ORIGINATION FORM

Proposed Revisions to a Standard Plans Index (Please provide all information — Incomplete forms will be returned)

Index Number: 521-423

Index Title: Traffic Railing - (32" Vertical Shape)

LAST REVISION 11/01/18	REVISION	DESCRIPTION:	 FY 2020-21 STANDARD PLANS	TRAFFIC RAILING - (32" VERTICAL SHAPE)	INDEX 521-423	SHEET 1 of 3
---------------------------	----------	--------------	--	--	------------------	-----------------

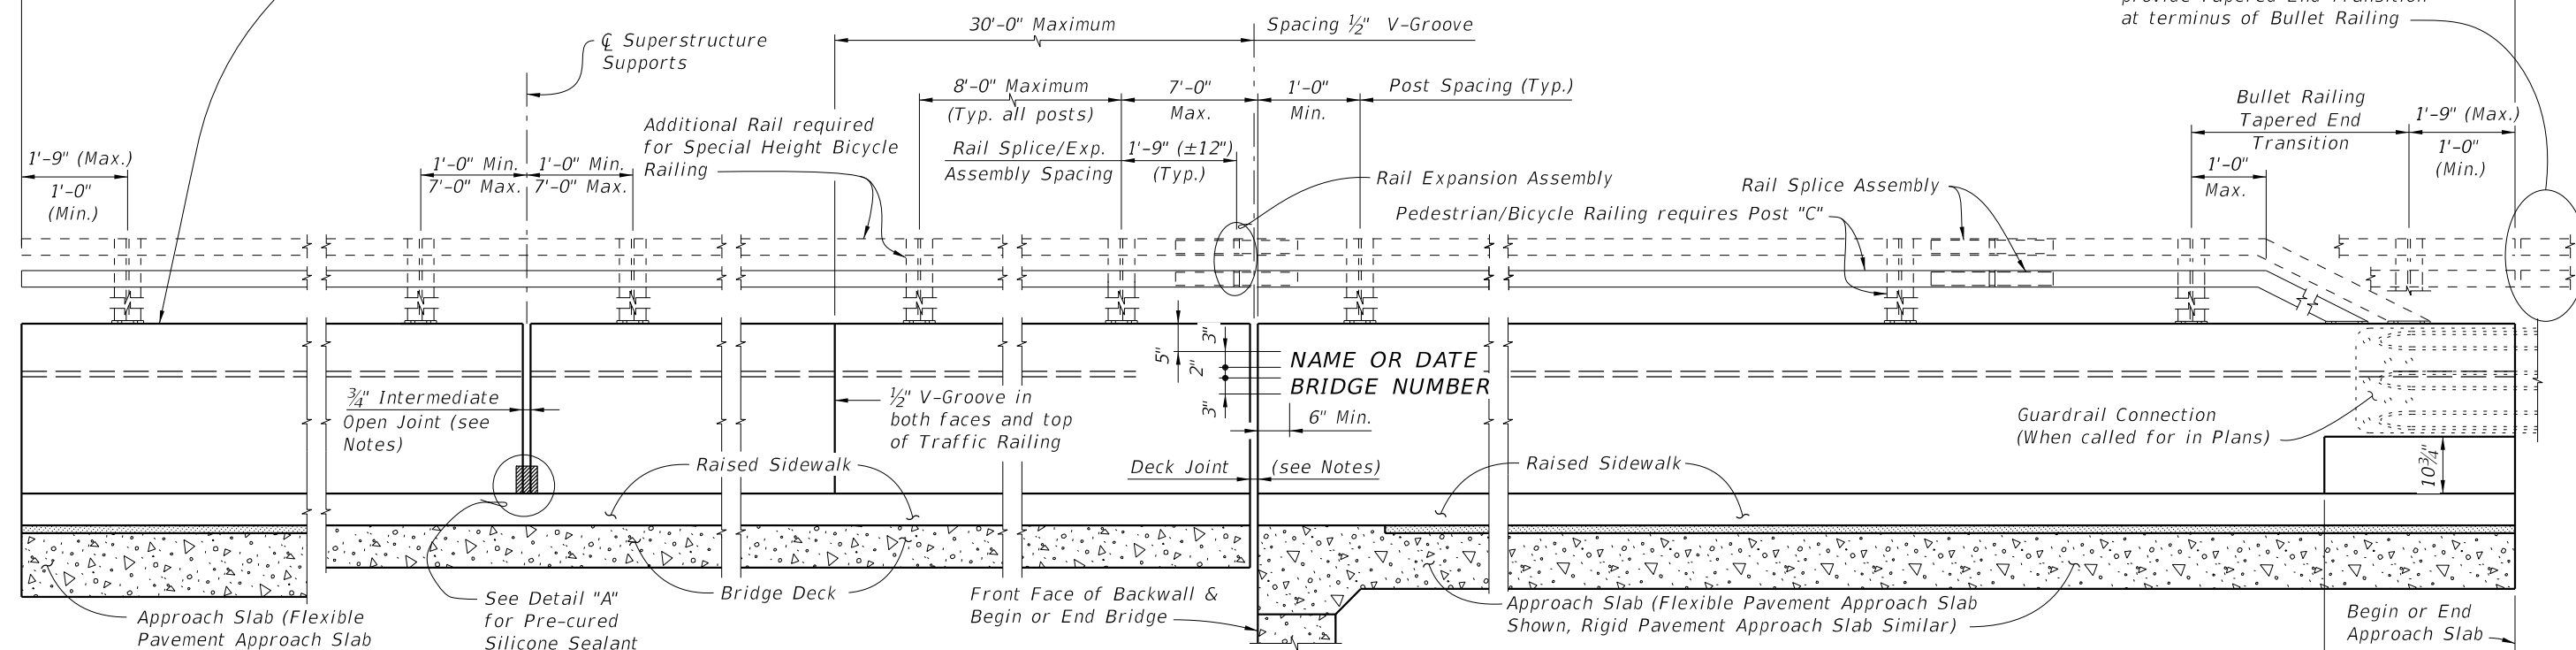
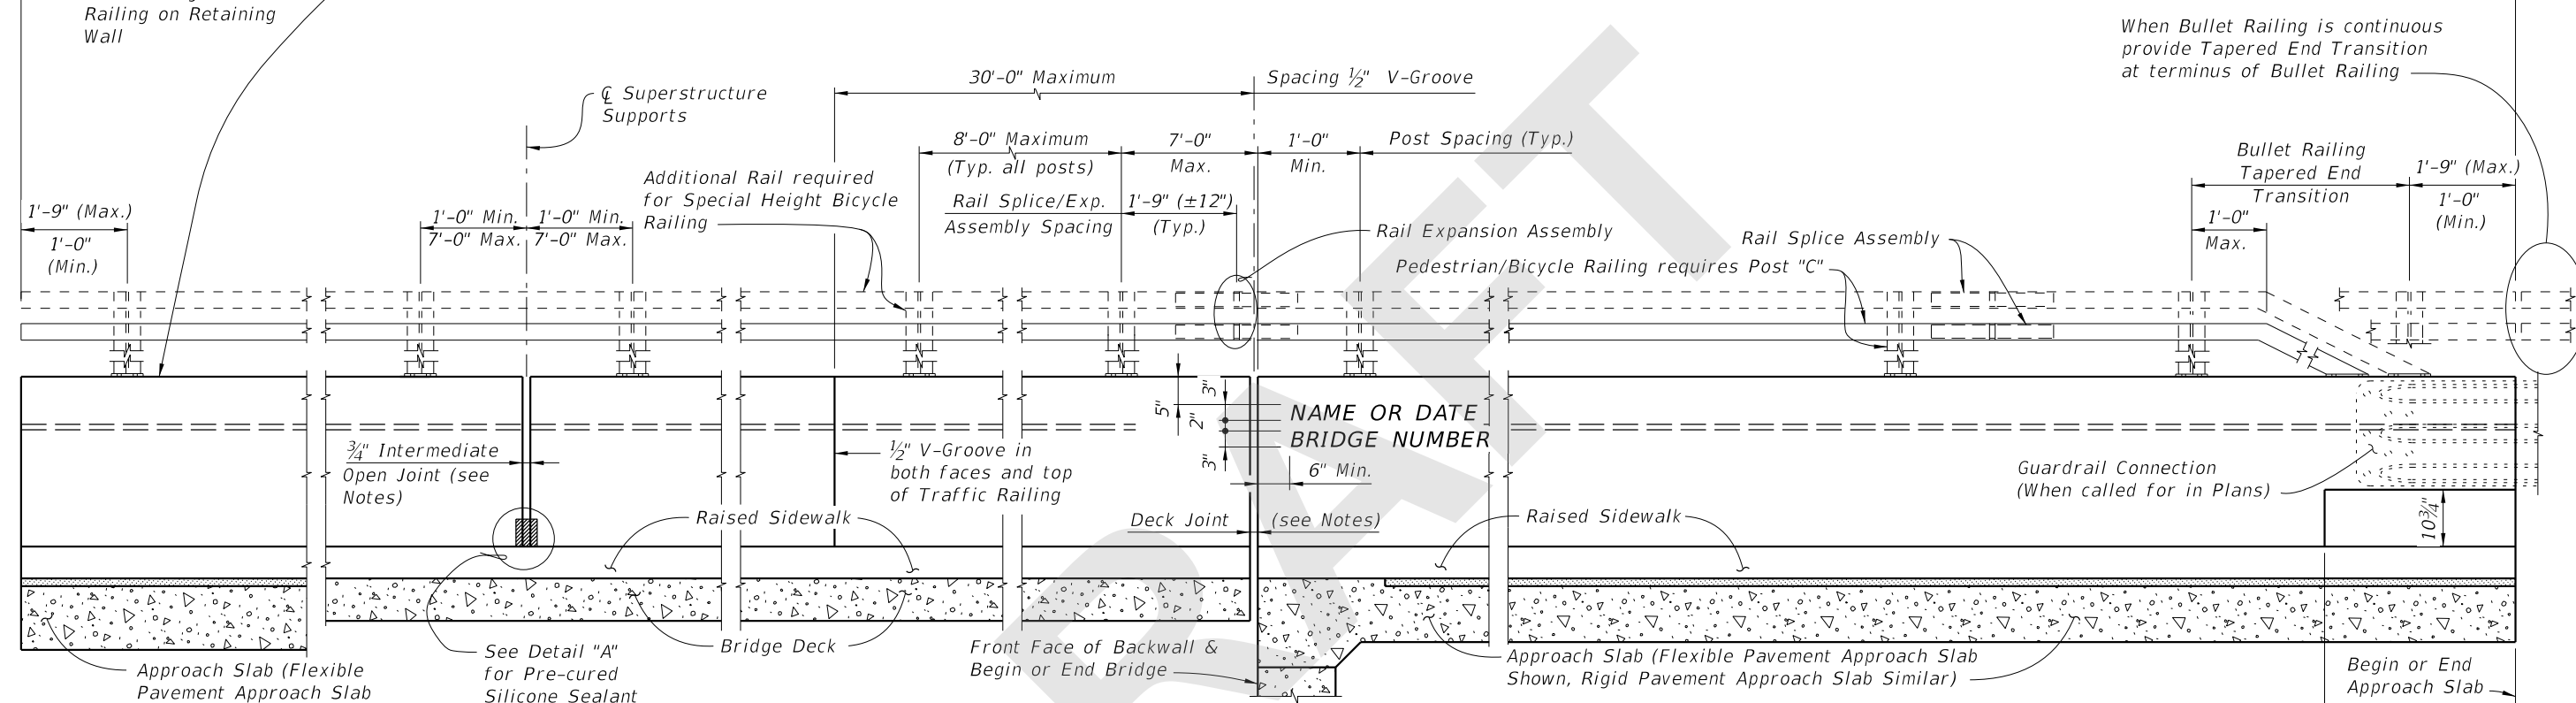
Numbered and reorganized Notes; Deleted MASH note.

MASH crash criteria met is in the SPI (not a construction note). Numbered notes to make them consistent with other Indexes.

~~This railing has been structurally evaluated to be equivalent or greater in strength to other safety shape railings which have been crash tested to NCHRP Report 350 TL-4 and MASH TL-4 Criteria.~~

1. Materials: See Structures Plans, General Notes
2. Guardrail Connection Details: See Index 534-001
3. Traffic Railings may be constructed perpendicular to the sidewalk surface. If an adjoining railing is constructed plumb, transition the end of the Traffic Railing from perpendicular to plumb over a minimum distance of 20'-0". The cost of all modifications will be at the Contractor's expense.

4. Name, Date & Bridge Number: Place the Name and Bridge Number on the Traffic Railing on the driver's right side when approaching the bridge. Place the Date on the driver's left side when approaching the bridge. Use the Name as shown in the General Notes of the Structures Plans. The Date is the year the bridge is completed. For a widening when the existing railing is removed, use both the date on the removed rail and the year of the widening. Form letters and figures with 3/8" V-Grooves using preformed letters and figures. Black plastic letters and figures 3" tall may be used, if approved by the Engineer.

5. Open Joints: See the Superstructure Plans, Approach Slab and Retaining Wall Sheets for Deck Joint dimensions and orientation. Provide Open Railing Joints matching the dimensions of the Deck Joint at Deck Expansion Joint locations.

- A. For treatment of railings on skewed bridges see Sheet 3.
6. Open Joints: Provide 3/4" Open Joints at:
 - A. Superstructure supports where the slab is continuous.

- B. At ends of approach slabs when adjacent to retaining walls and at expansion joints on retaining wall junction slabs.
7. V-Grooves: Construct 1/2" V-Grooves plumb. Space V-Grooves equally between 3/4" Open Joints and/or Deck Joints and the at V-Groove locations on the Retaining Wall footing/junction slabs.

8. Barrier Delineators: Install Barrier Delineators on top of the Traffic Railing 2" from the face of the traffic side in accordance with Specification Section 705. Match the Barrier Delineator to the color (white or yellow) of the near edgeline.

9. For embedded conduit and junction boxes see Index 630-010.
10. For Traffic Railings with Pedestrian/Bicycle Bullet Railings see Index 515-021 and 515-022 for Notes, Details and post spacing.
